ENCLOSURE 2

C-200, OFFSITE DOSE CALCULATION MANUAL REVISION 45  
(230 PAGES)

<b>FPL</b>	<h1 style="margin: 0;">ST. LUCIE PLANT</h1> <h2 style="margin: 5px 0 0 0;">CHEMISTRY OPERATING PROCEDURE</h2> <p style="margin: 0;">SAFETY RELATED REFERENCE USE</p>	Procedure No. <div style="border: 1px solid black; border-radius: 50%; width: 40px; height: 40px; margin: 5px auto; display: flex; align-items: center; justify-content: center;"> <span style="font-size: 24px; font-weight: bold;">C-200</span> </div> Current Revision No. <span style="font-size: 24px; font-weight: bold;">45</span>
---	--	---

Title: **OFFSITE DOSE CALCULATION MANUAL (ODCM)**

**FIGURE 1-2  
ENVIRONMENTAL SAMPLE LOCATIONS (10 MILES)**

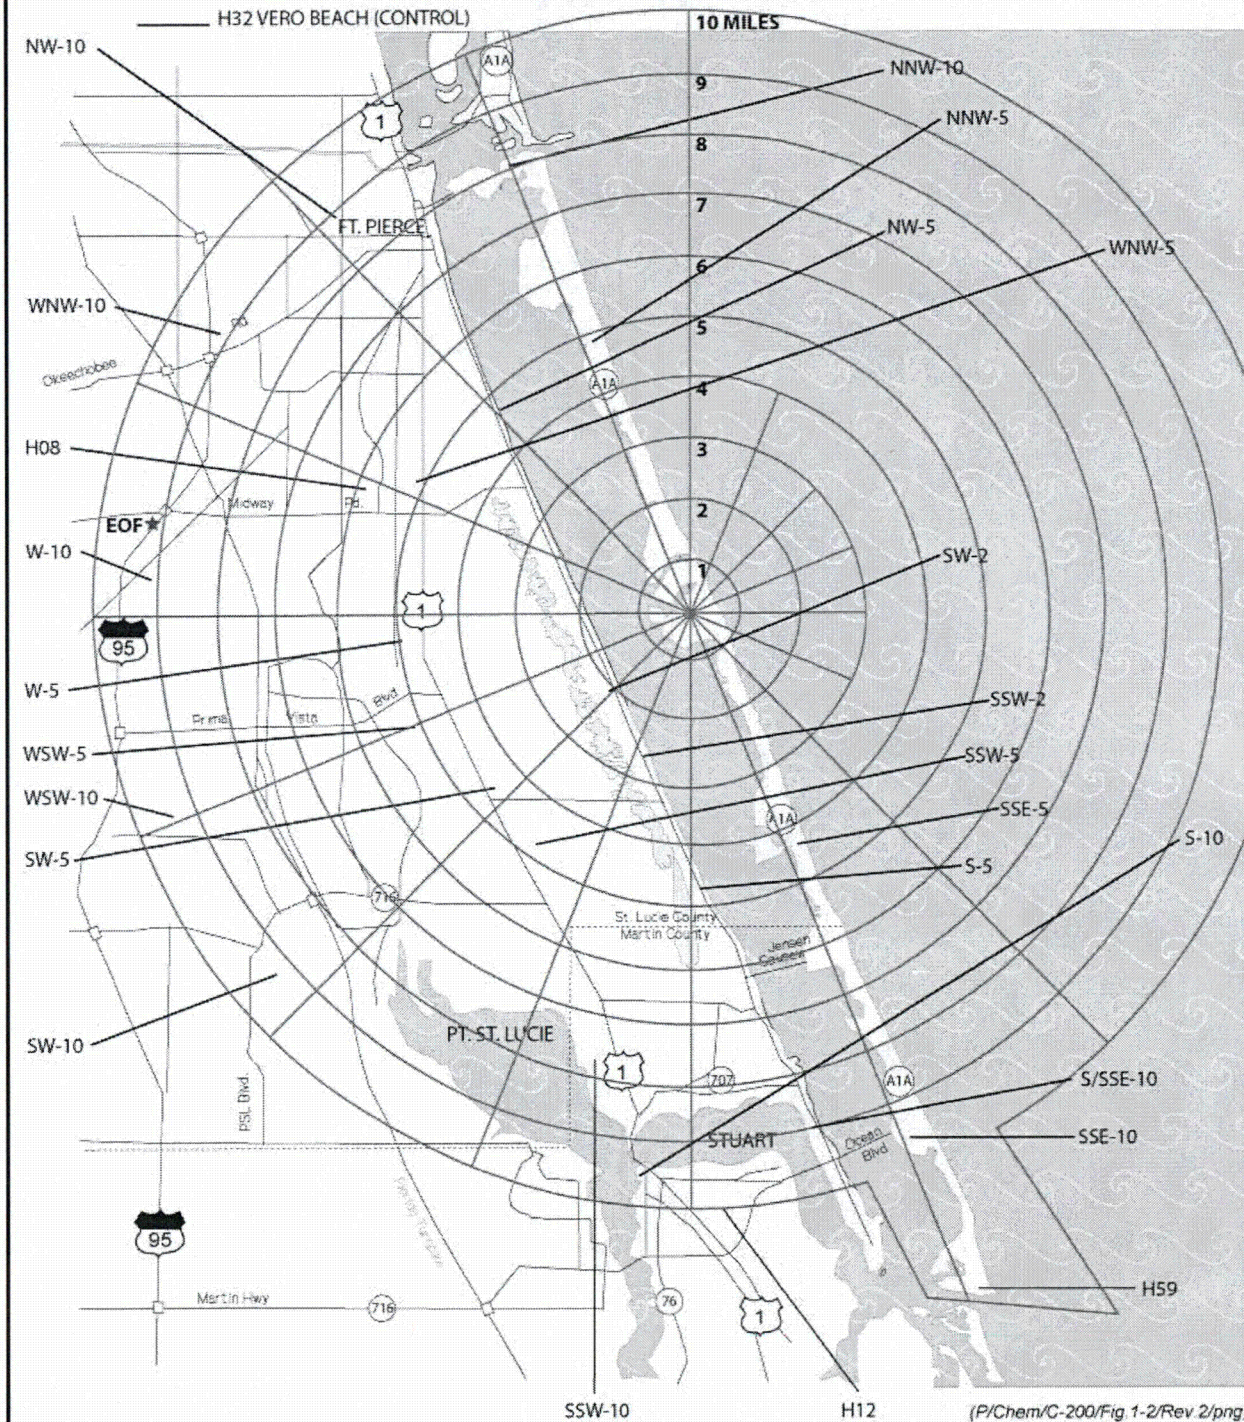
Incorporated PCR 1994917 to remove the goat from Figure 1-2 located at "WSW-3.5, GOAT". The goat is no longer at this location as documented in the Annual Land Use Census. (Author: J. Hunt)
